P 28818
A 25302

SEWAGE DISPOSAL SYSTEM

MARYLAND STATE DEPARTMENT OF HEALTH*

SUBDIVISION Simpson Woods ROAD 7210 Meadow Wood Way LOT 5, Sec. 1

INDICATE NORTH. - NAME ADJOINING ROADWAY AS BASE LINE.
MEADOW WOOD WAY

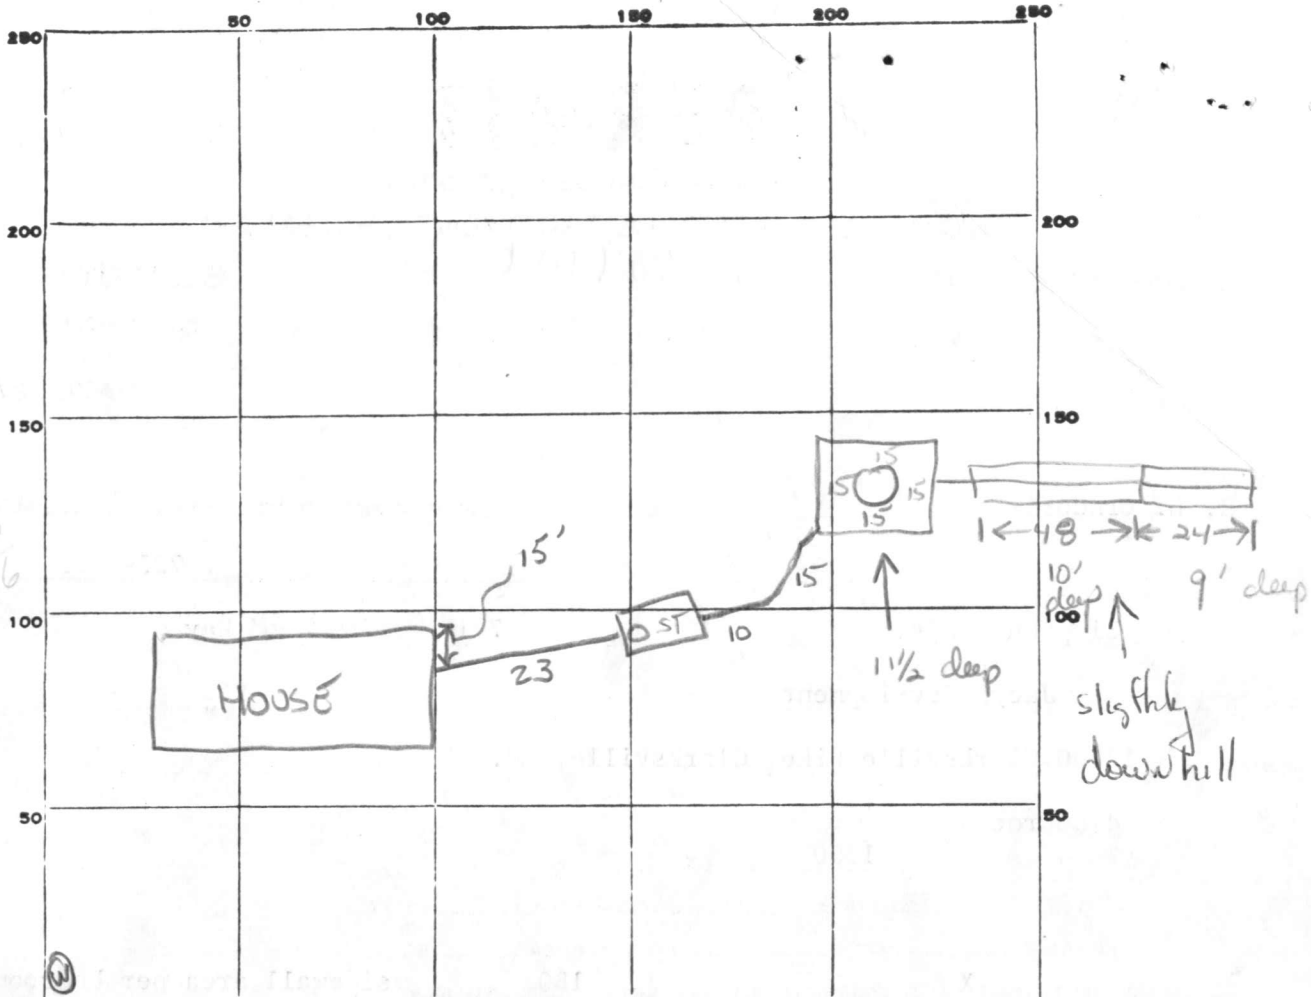
REMARKS 13 Oct 78 - OK to backfill from house to drywell. You are 90 feet short (Effective depth begins at 5') and need to extend trench AN addition 20 feet (70 feet total length). OK to Add gravel to 48' section but call before adding gravel to extension. (GLK)
16 Oct 78 - Call for final when gravel is added to end section of trench. OK to backfill 1st 40' of trench (GLK) 17 Oct 78 FINAL OK (GLK)

DATE SYSTEM APPROVED 17 Oct 78 INSPECTOR G. Keller
